# TEXAS DEPARTMENT OF TRANSPORTATION

## Change Order Third Party Funding Notification Sheet

CCSJ: 3510-04-019CO #: 18Project: STP 2022 (936)MM, etc.District: HoustonHighway: SH 99Contractor: Webber, LLCCounty: Fort BendContract #: 351004019

DESCRIPTION: 102-IN DRILLED SHAFT DOWEL PACKAGE DELAY  
REASON: 1B - 1B-INCORRECT PS&E (CONSULTANT DESIGN)  
SECONDARY REASON(S):

SH 99  
BENT NOS. 2 & 8  
SH 99 SB EXIT RAMP

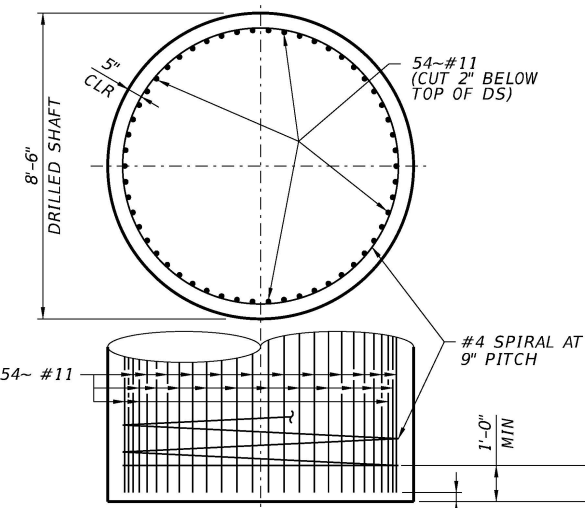
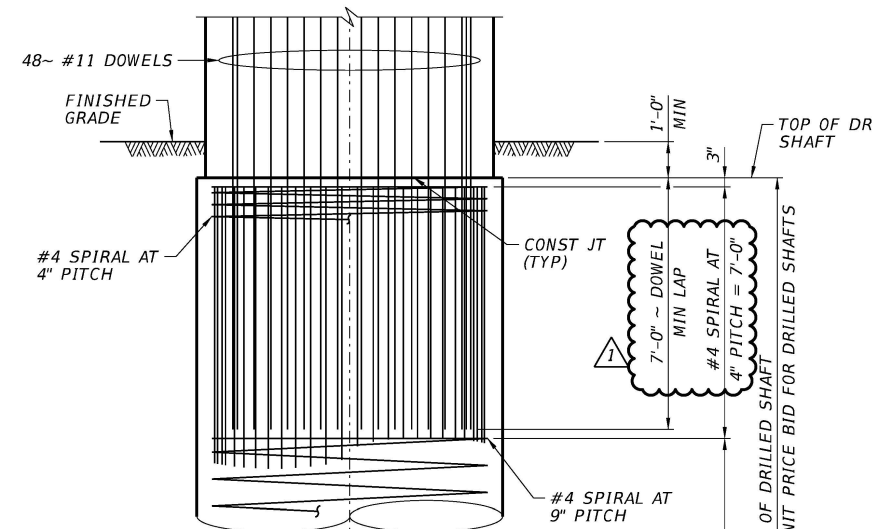
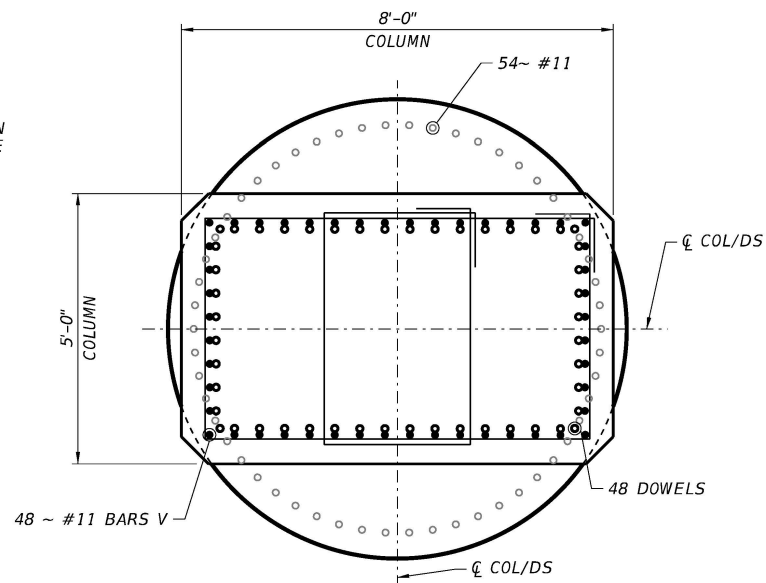
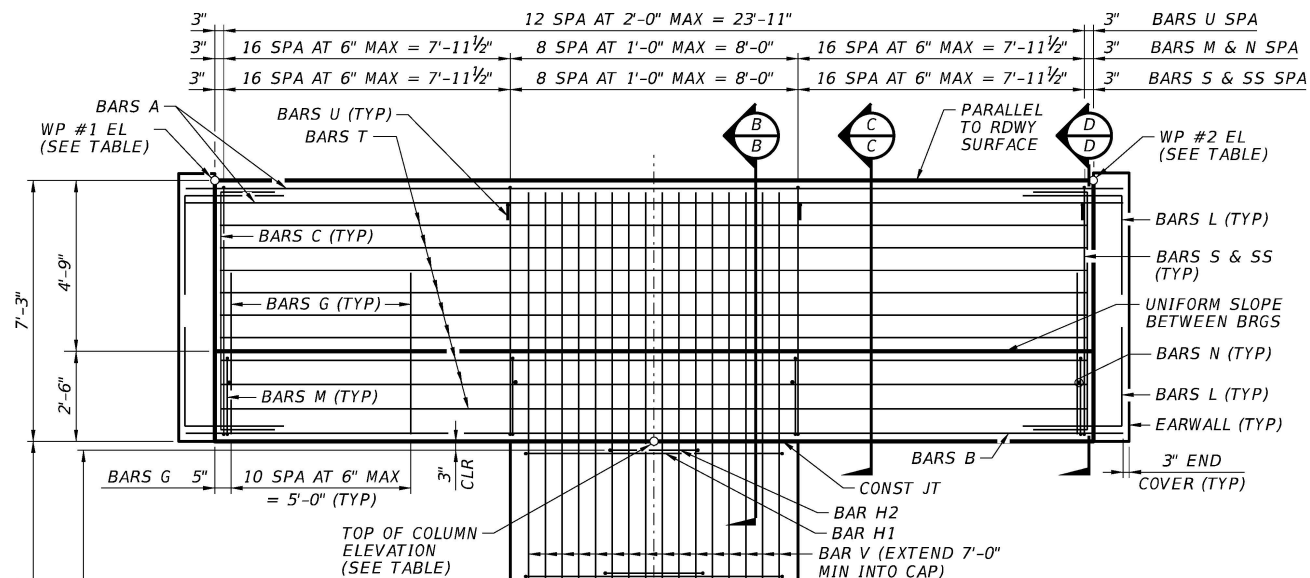
NO.	DATE	REVISION	APPROV.
1	8/10/23	MODIFY DOWEL LAP LENGTH.	YFS

SH 99  
BENT NOS. 2 & 8  
SH 99 SB EXIT RAMP

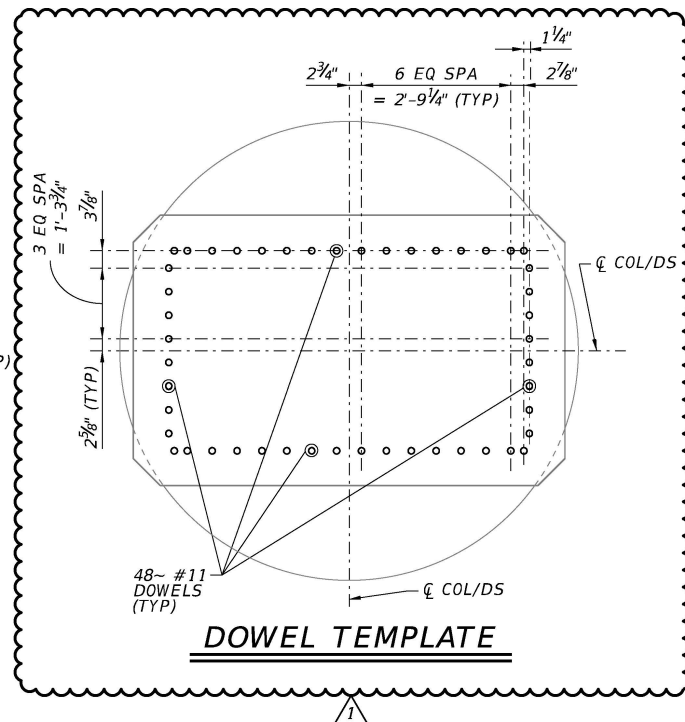
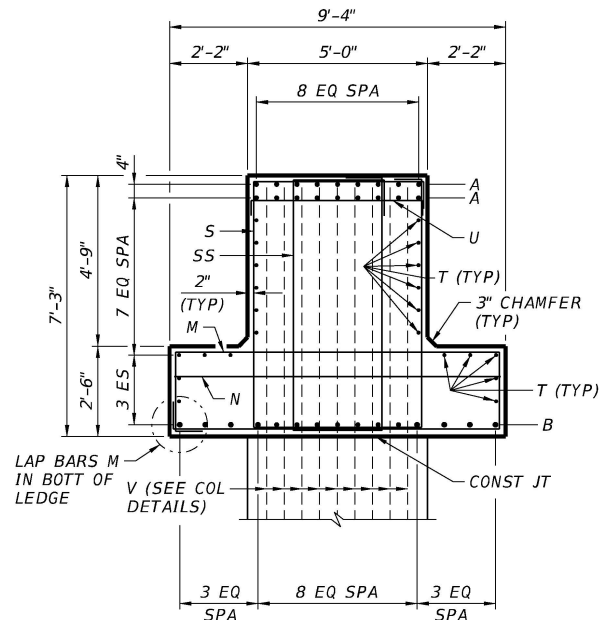
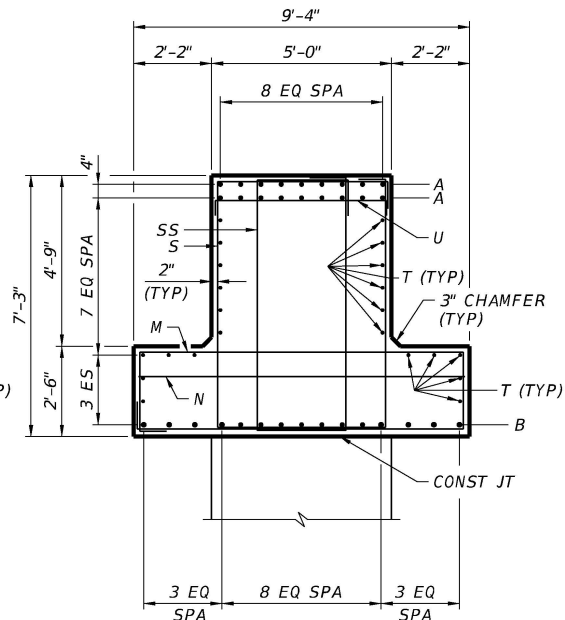
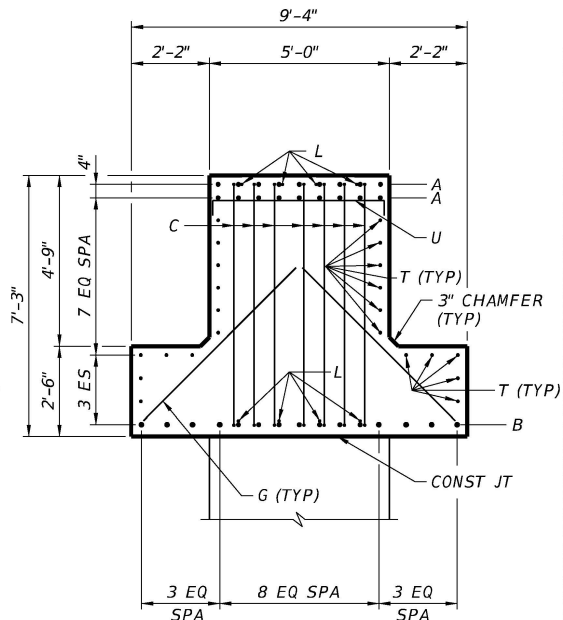
1	8/10/23	MODIFY DOWEL SPACING.	YFS
NO.	DATE	REVISION	APPROV.

SH 99  
BENT NOS. 3 & 4  
SH 99 SB EXIT RAMP

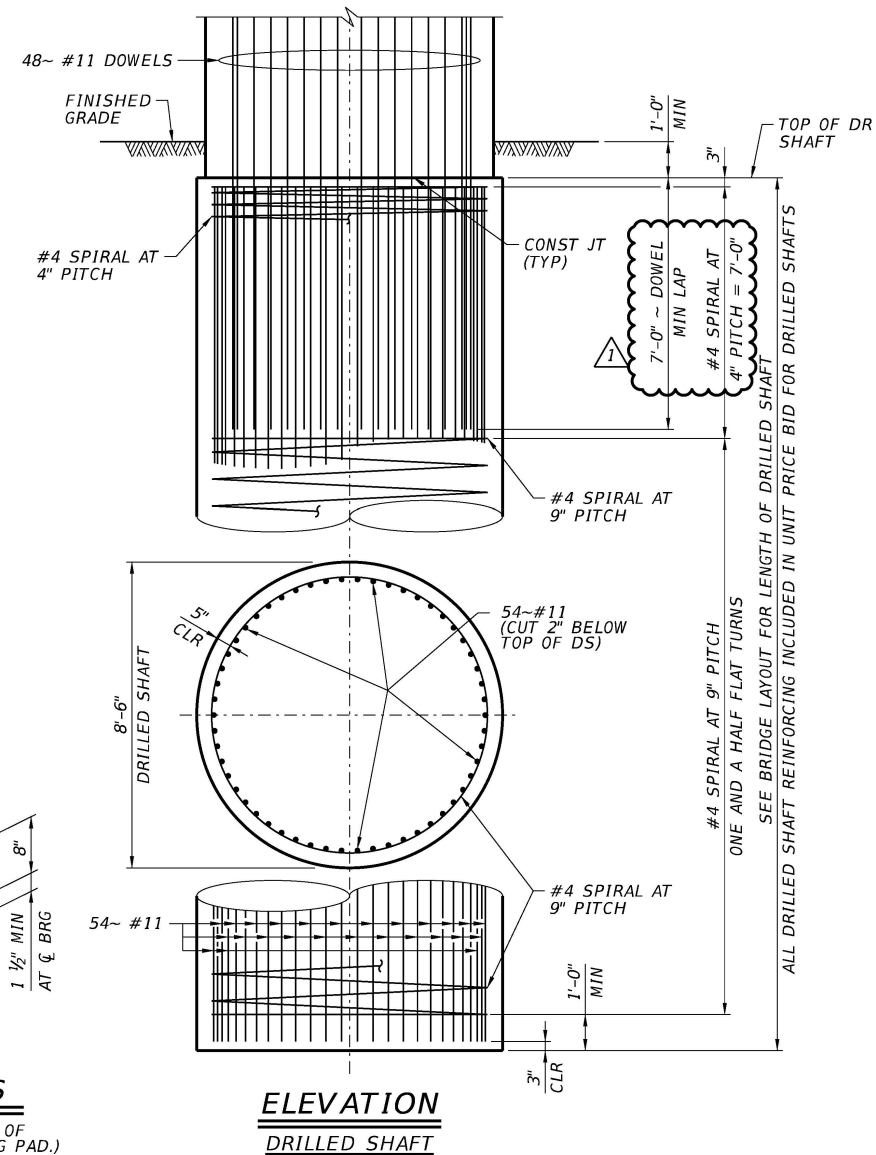
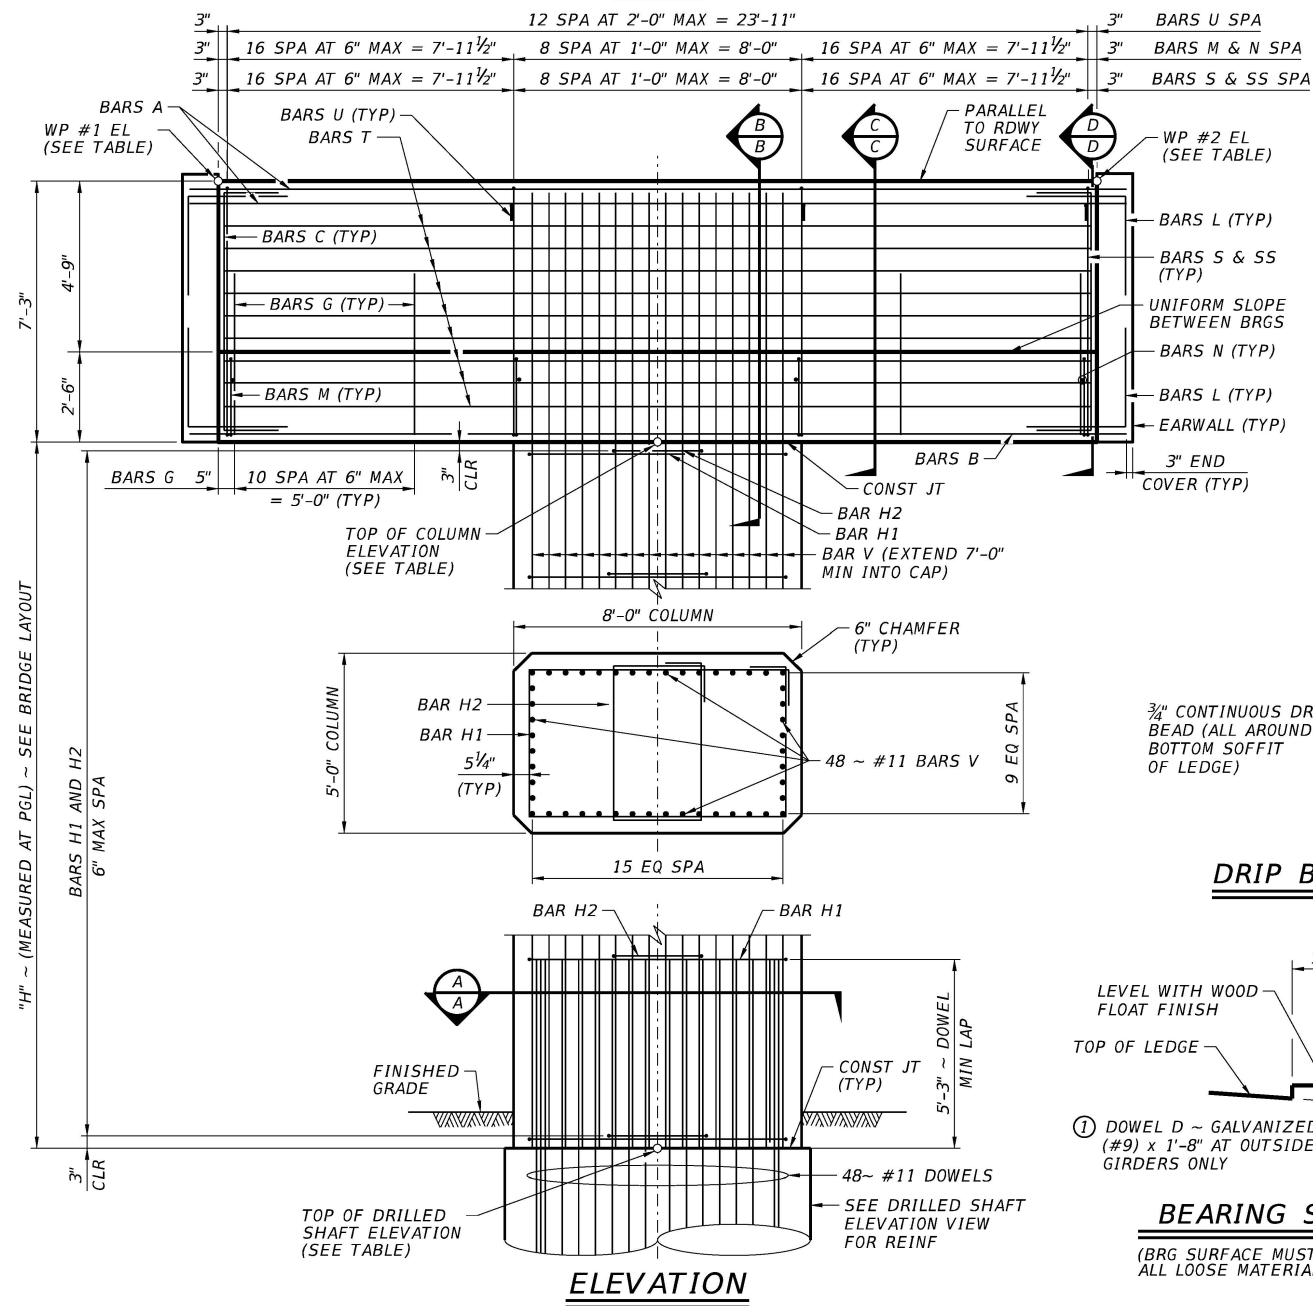
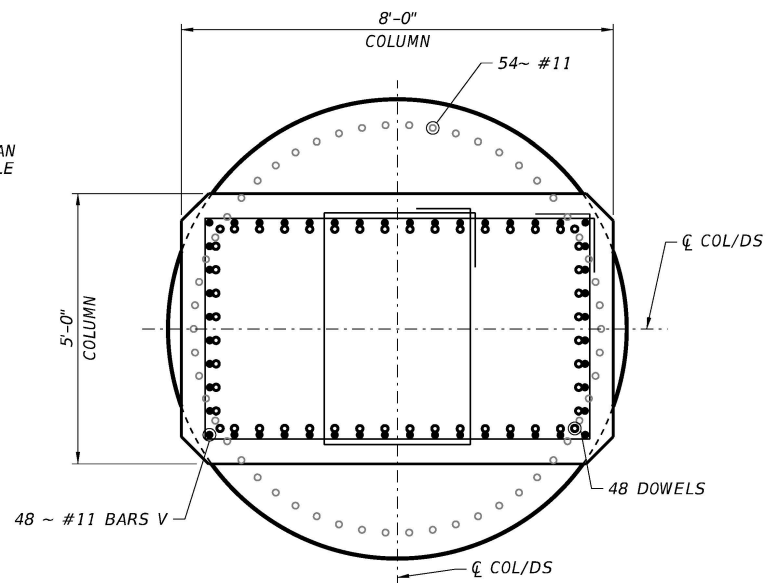
NO.	DATE	REVISION	APPROV.
1	8/10/23	MODIFY DOWEL LAP LENGTH.	YFS

SH 99  
BENT NO. 5

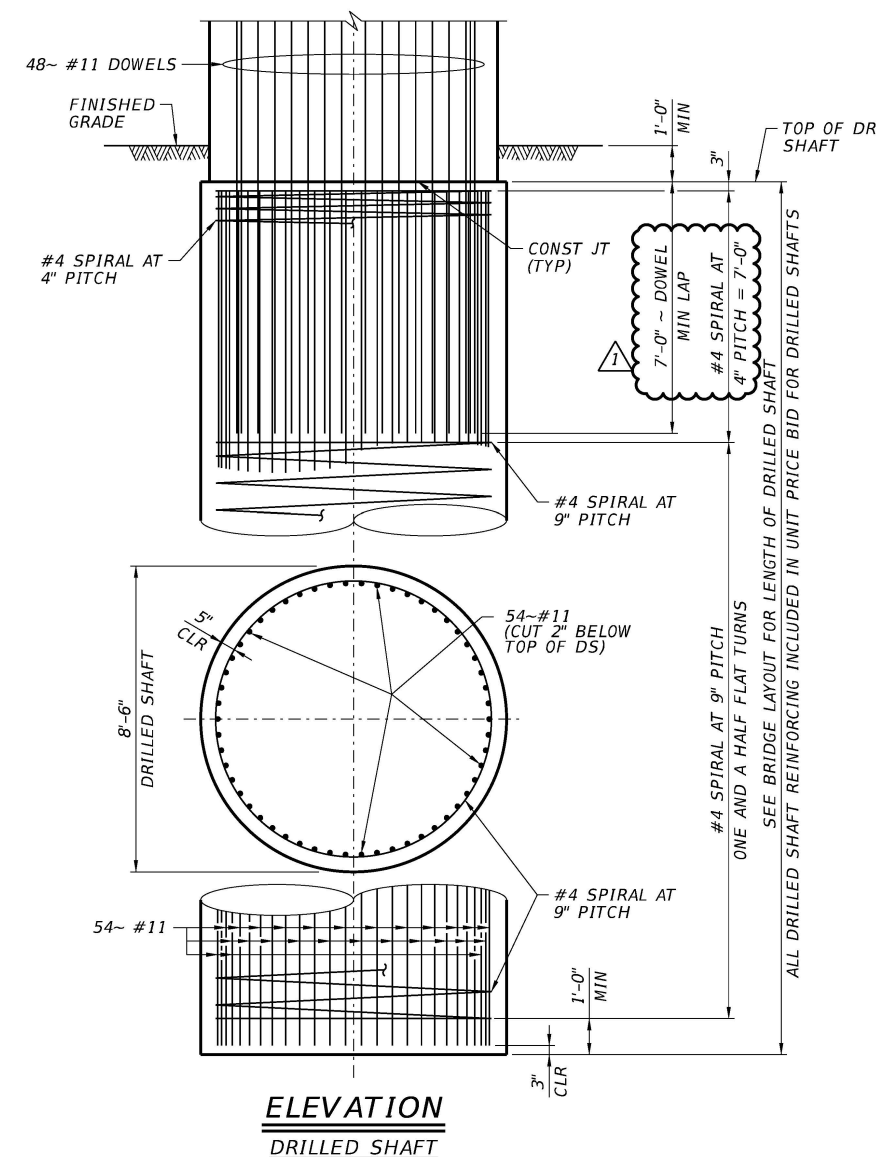
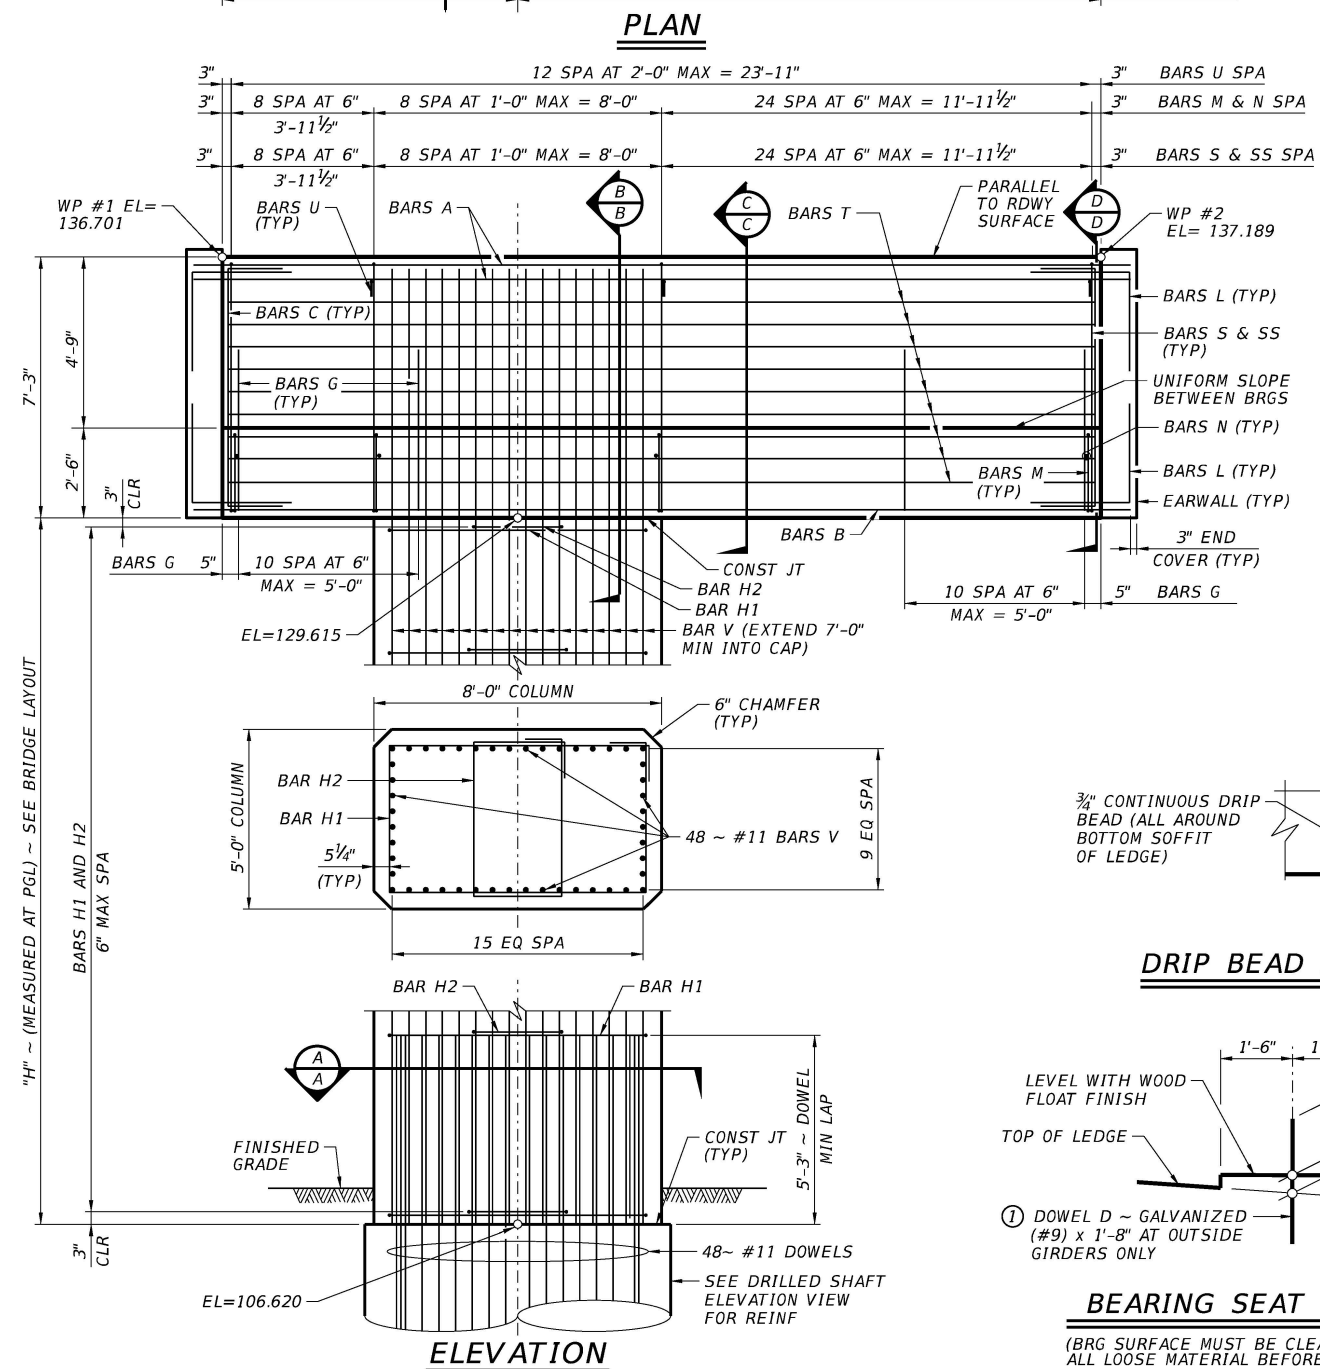
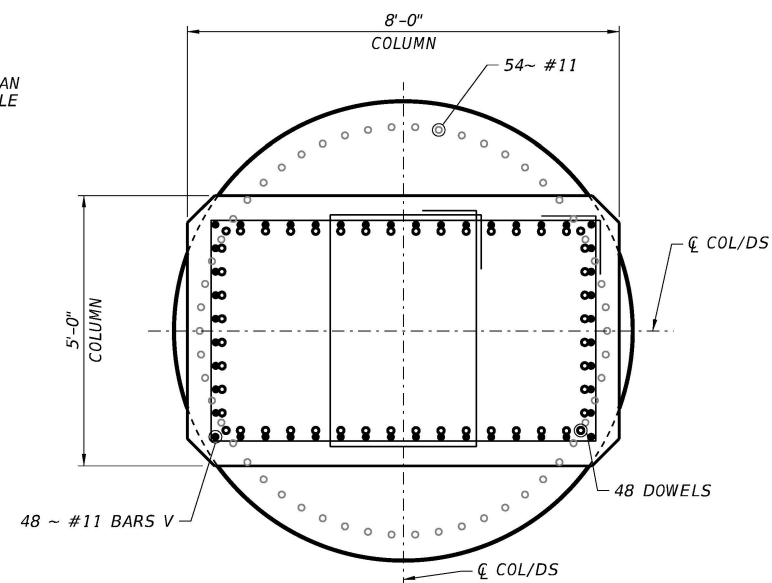
1	8/10/23	MODIFY DOWEL LAP LENGTH.	YFS
NO.	DATE	REVISION	APPRO
